Declaration of Dr. Robert E. Moran.....DECL 11

Declaration of Dr. Ronald L. SassDECL 69

UNITED STATES OF AMERICA
NUCLEAR REGULATORY COMMISSION

In the Matter of)
)
STRATA ENERGY, INC.,) Docket No. 40-9091-MLA
)
(Ross In Situ Recovery Uranium Project))
(Materials License Application)

Figure 2.6-7

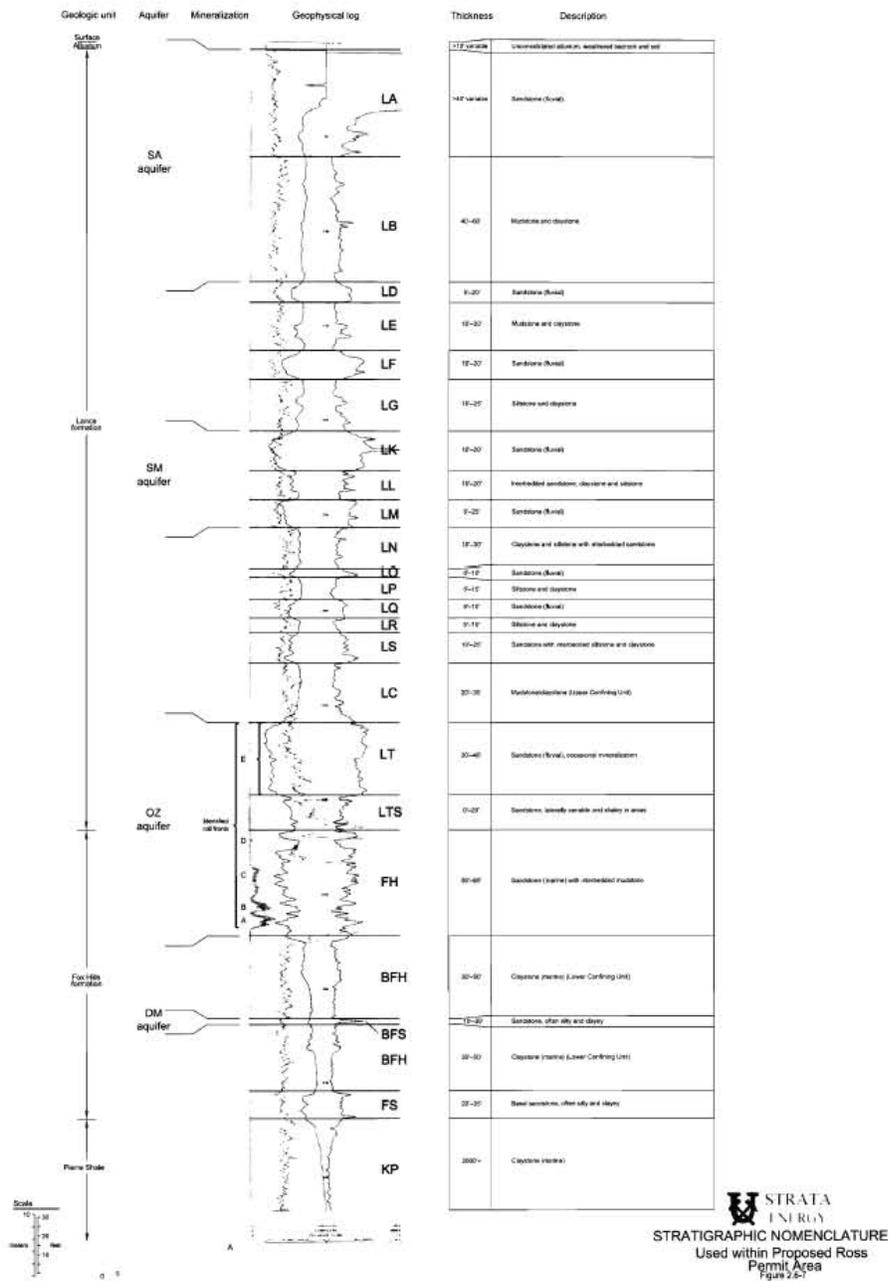
Figure 2.6-7 depicts the stratigraphic nomenclature that is used within the proposed project area. This figure illustrates the geophysical log and corresponding lithology obtained from exploration drill hole number RMR008, the location of which is shown on Figure 2.6-4. This particular drill hole was chosen as the “type log” for the proposed project area due to the clarity of the geophysical logs and the associated stratigraphic descriptions from land surface to the top of the Pierre Shale (Page 2-89).

17. Figure 2.6-4 is a low-resolution map of the area surrounding the project area. It shows drill hole number RMR008 but does not relate it to any information about the ore body. Figure 2.6-7 shows the well log from RMR008 with the various strata identified. It shows that the gamma radioactivity occurs in the OZ (ore zone) at five different levels. It also shows that the Pierre Shale conformably (having the same stratification direction)

Figure 2.7-14. Regional Baseline Groundwater Monitoring Network

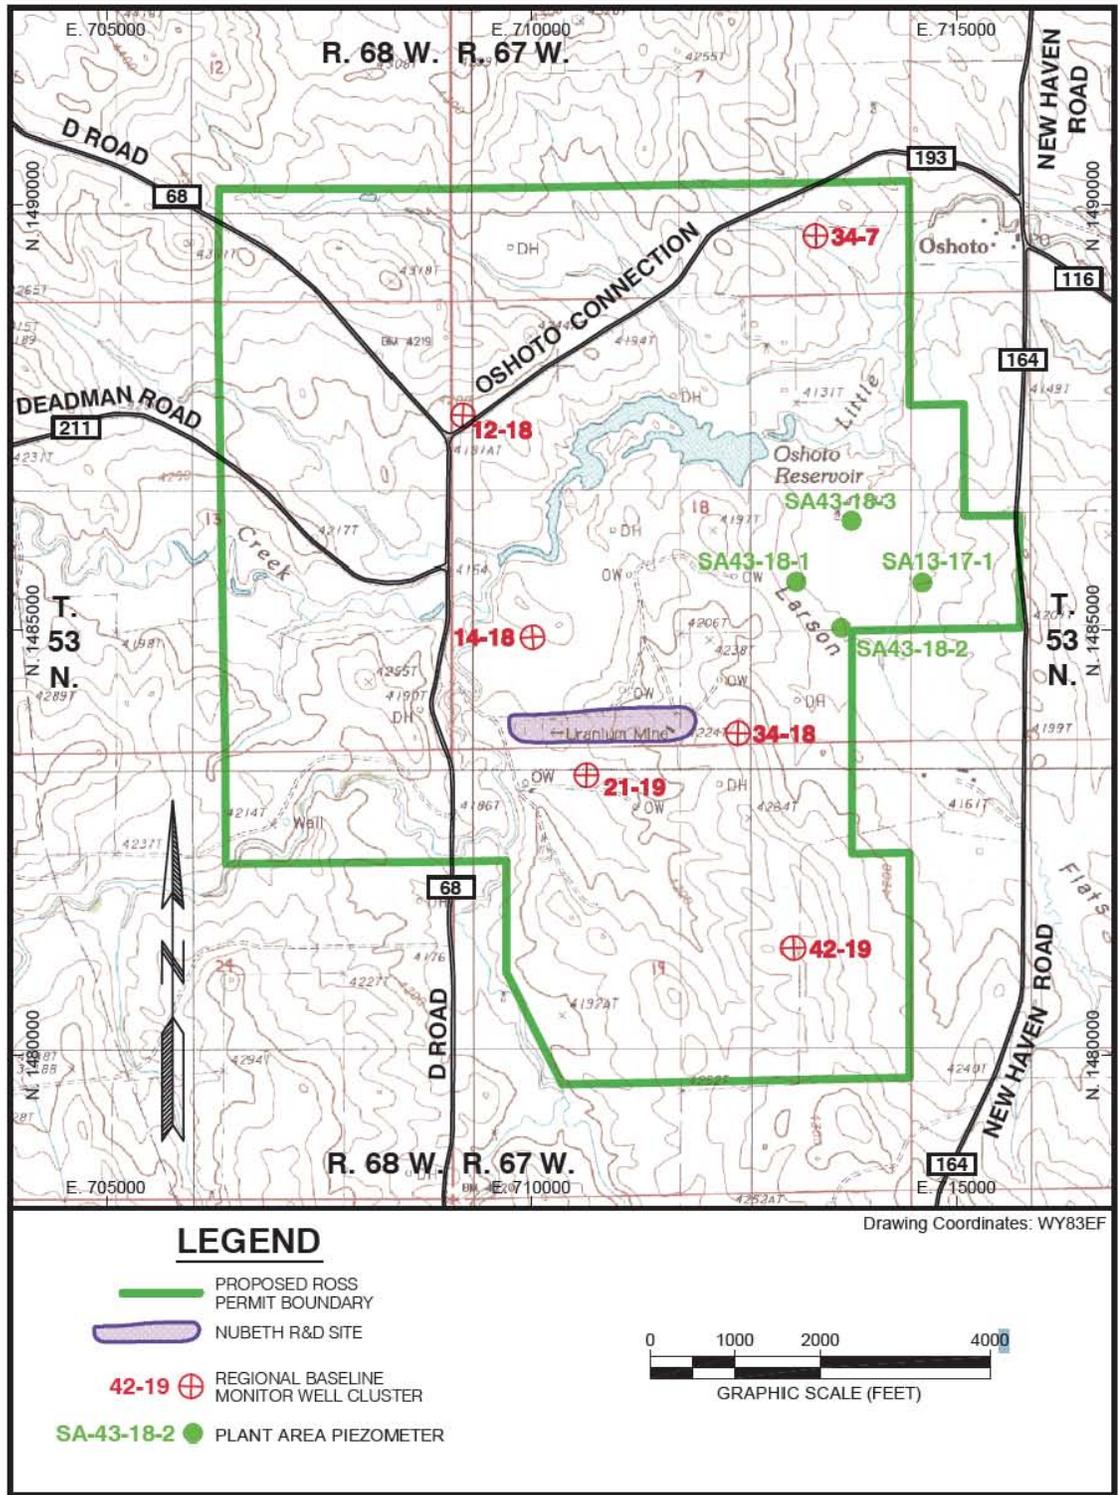
44. The application is also not clear in identifying how previously monitored wells will continue to be tested and monitored throughout the life of the project. TR Figure 2.7-14, TR, pg. 2-156, is titled "Regional Baseline Groundwater Monitoring Network." On the contrary, this map covers predominantly the *site-specific portions* of the proposed Ross project. The Application is not clear as to precisely which wells be monitored, both the on-site Strata wells and the buffer zone wells (within 2-miles of the project boundary). In order to be meaningful, future monitoring should include many of the wells previously monitored during both historic and Strata Application monitoring. Otherwise, Strata will be using different wells to determine post-mining water quality than they used to determine pre-mining water quality.

24. Strata did drill six clusters of baseline monitoring wells as located in figure 2.7-14 .

Figure 1

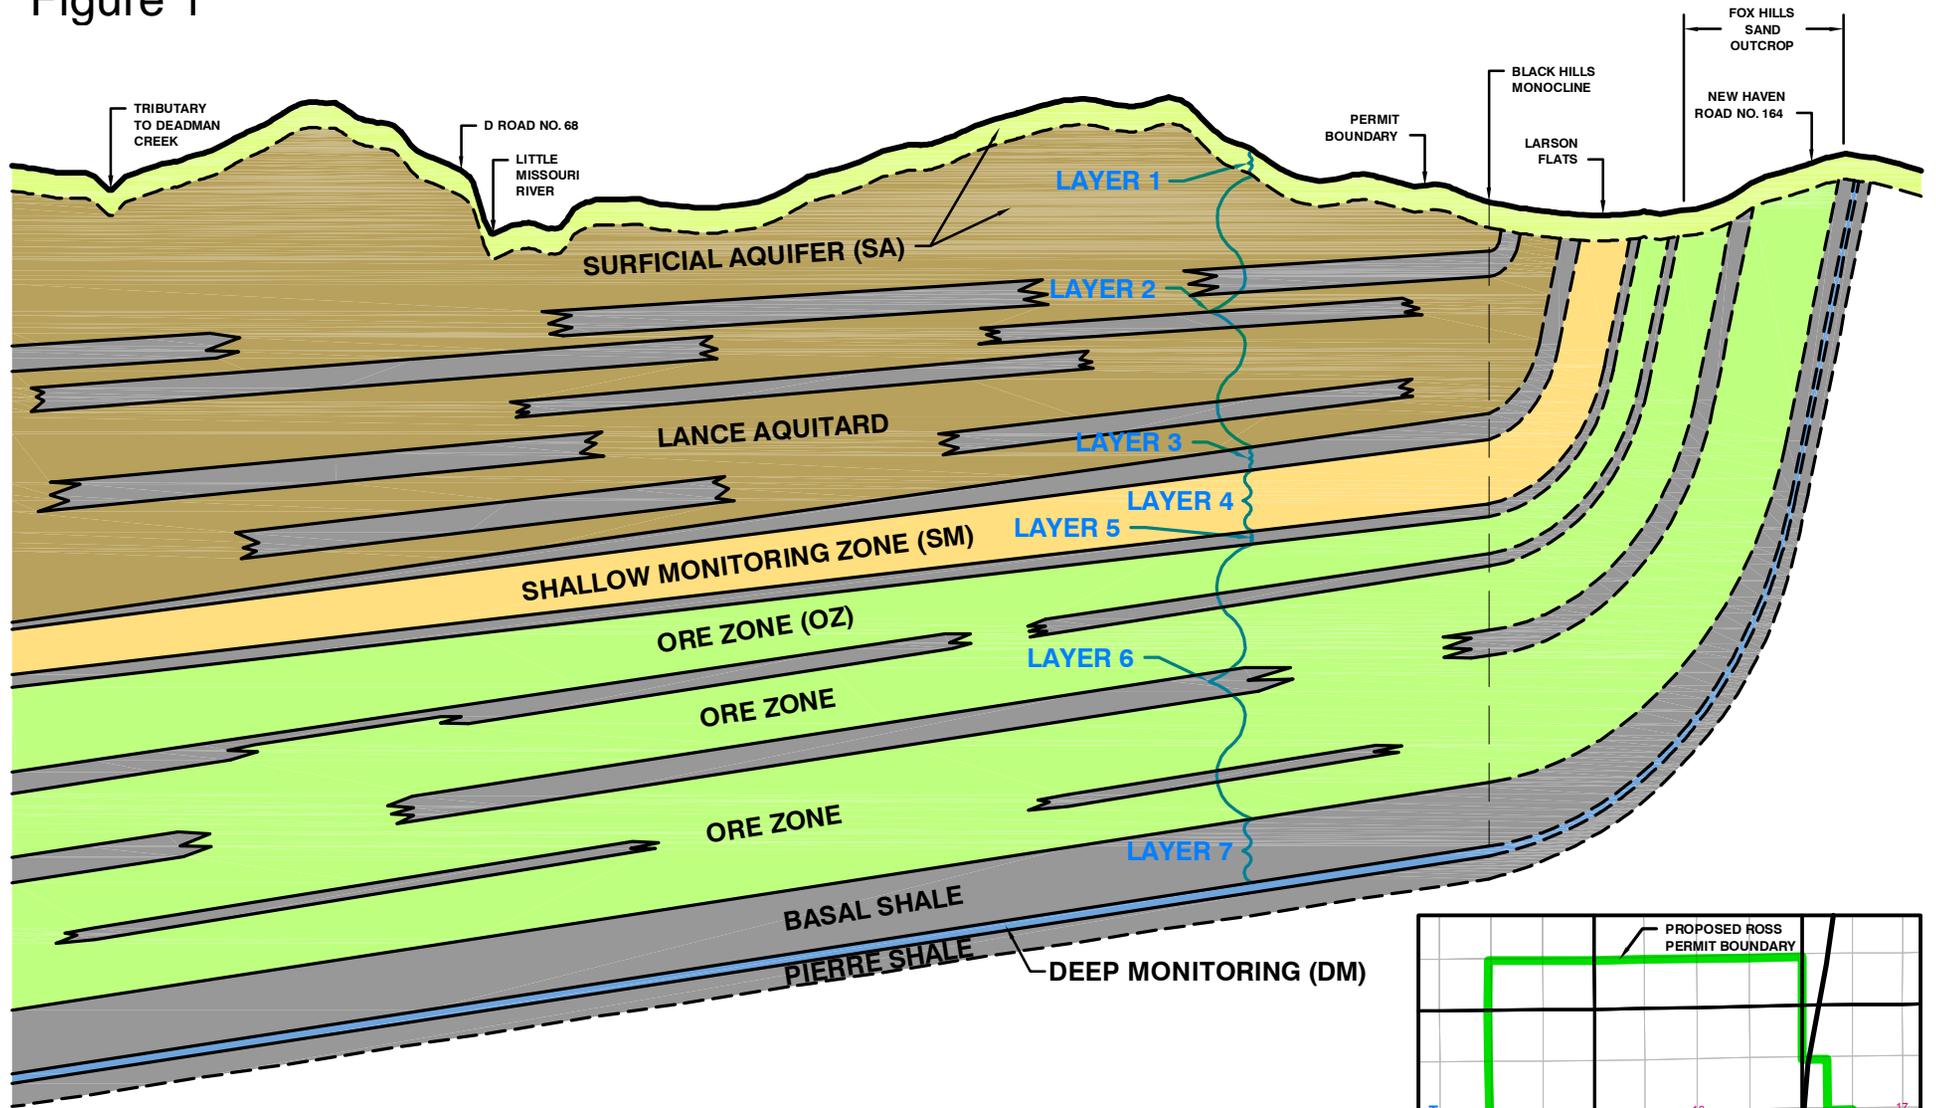
area. The aquifers noted above are shown in Figure 1 (taken from the Ross In Situ Recovery NRC License Application, TR Addendum 2.7-H, Fig. 4.1-2, pg. 39).

14. Clearly, there was no effort to plug and abandon the boreholes from the bottom up and pathways between the water horizons exist now; and they existed back in 1978 when Nubeth performed their pilot scale ISL operation within the present permit boundary (Figure 1).

Figure 2

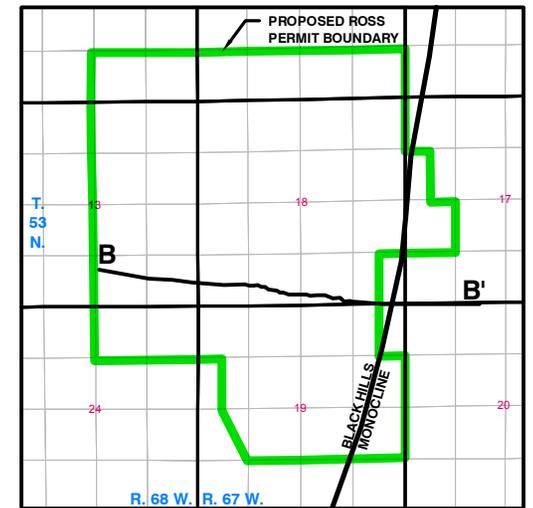
13. Additionally, there are hundreds of pathways between the OZ and other water horizons due to the nearly 2,000 exploration boreholes drilled in the project area, as shown in Figure 2.

17. The six cluster wells are an insufficient number of wells to characterize the baseline water quality of the water horizons in the Ross permit area. *See* Figure 2. Although the application states additional baseline well clusters will be installed, all the proposed well clusters are in ore zones (Technical Report, Figure 5.7-9; p. 5-106). This biases water quality samples to high values and does not account for the collection of representative samples from the surrounding aquifer that will be part of the aquifer exemption permit.

400' BY 400' GRID

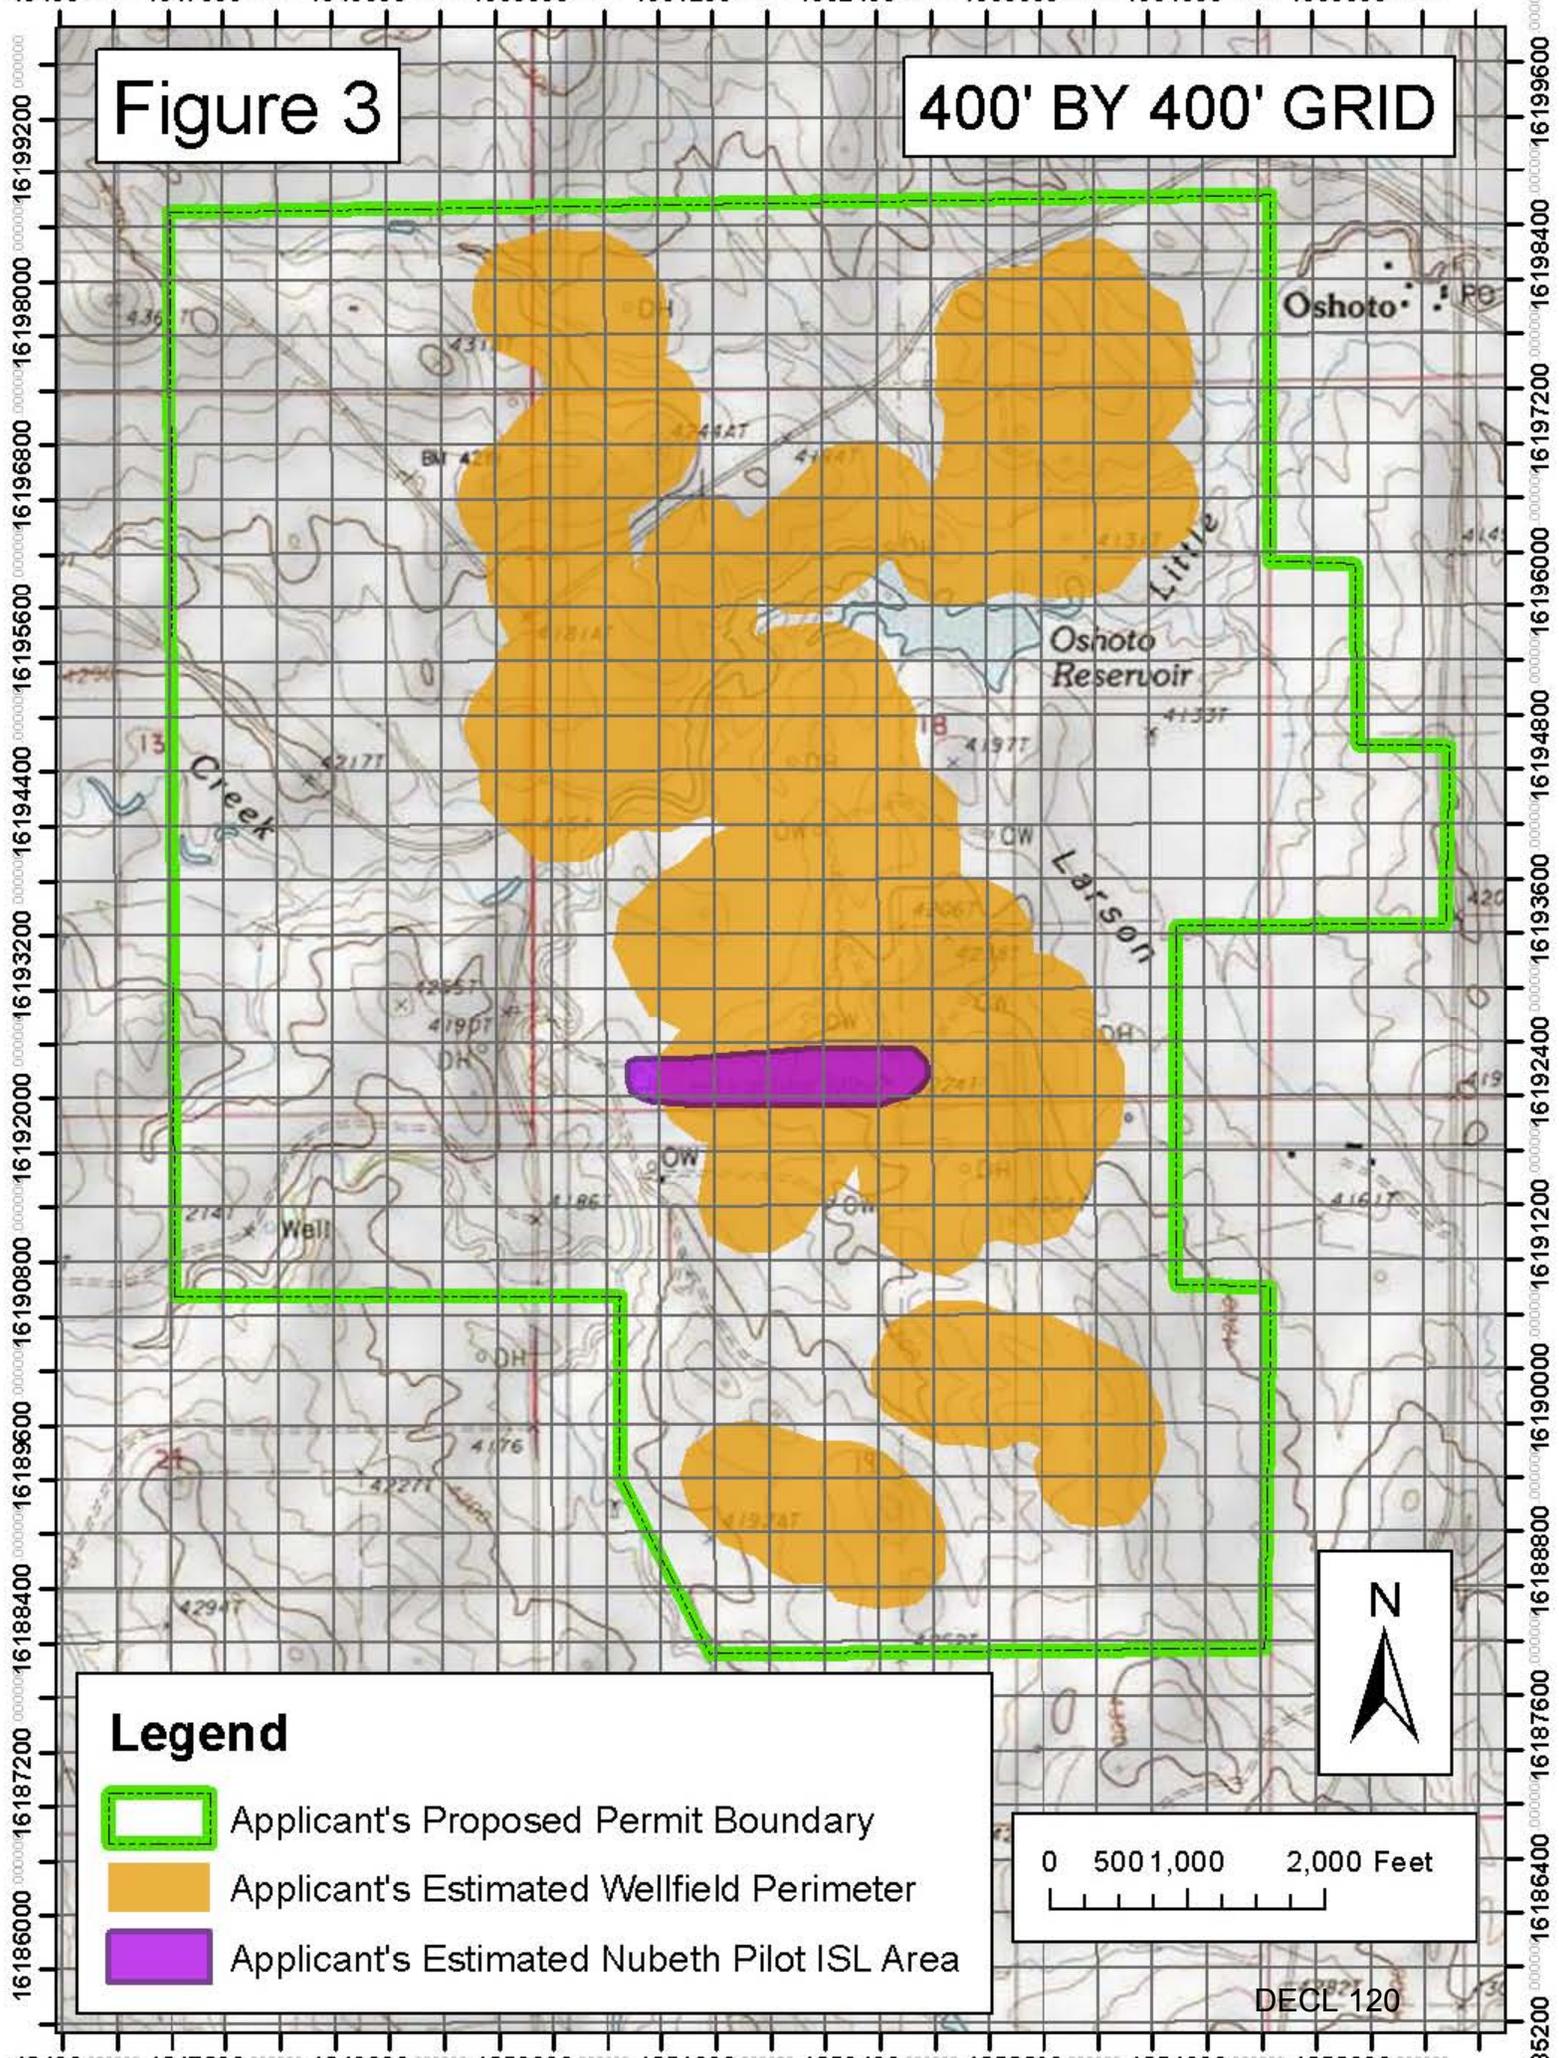
18. A statistically valid approach for establishing baseline water quality in the mine area is to locate baseline wells with a systematic grid or by random selection (Gilbert, 1987; Matzke et al., 2007). For a systematic grid, a 400-by-400 foot grid (160,000 ft² or about 4-acre cells) should be placed over the proposed mine area to ensure that a minimum of one well is placed in every 4 acres (NRC, 2003; p. 5-39). Given the proposed mine area illustrated on Figure 2.1-3 in Section 2 of the Technical Report (as shown on Figure 2), approximately two-thirds of the Ross permit area is covered by proposed well fields. The Ross permit area covers about 1,866 acres, and two-thirds of this is 1,250 acres. Therefore, if the recommendation is to place one baseline well in every four acres, there should be approximately 312 wells located on a systematic grid that covers the proposed mine field. Figure 3 illustrates the systematic placement of 312 wells on a 400 by 400 ft grid across the proposed mine fields (map data for Applicant's Proposed Permit Boundary, Applicant's Estimated Wellfield Perimeter, and Applicant's Estimated
